## IEEE 802.3 Ethernet Working Group Liaison Communication

Subject: Liaison reply to ISO/IEC JTC 1/SC 25 from IEEE 802.3 in response to 3N926

Date: 15th July 2010

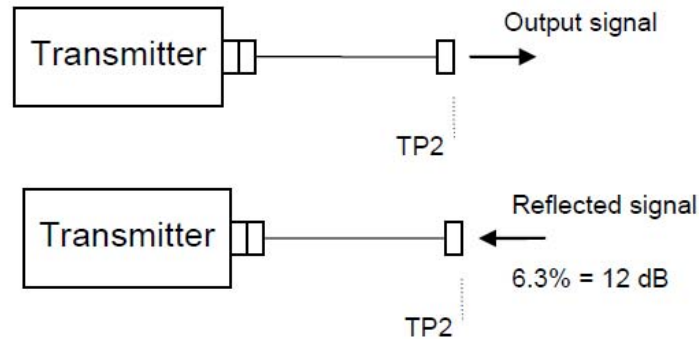
Q1. Do we understand correctly that this 12 dB requirement includes the optical return loss from the connectors that are plugged into the equipment at each end of the channel?

*There was also a Note: Please note; the ISO/IEC 11801 channel does not include the performance of the connecting hardware at the equipment interface.*

A1. The 12 dB optical return loss tolerance parameter is used in two **transmitter** performance requirements (RIN and TDP) defined at TP2, as illustrated below. The 12dB value represents the return loss when the transmitter is connected to a receiver. At the receiver, the -12 dB reflectance requirement includes the connector.
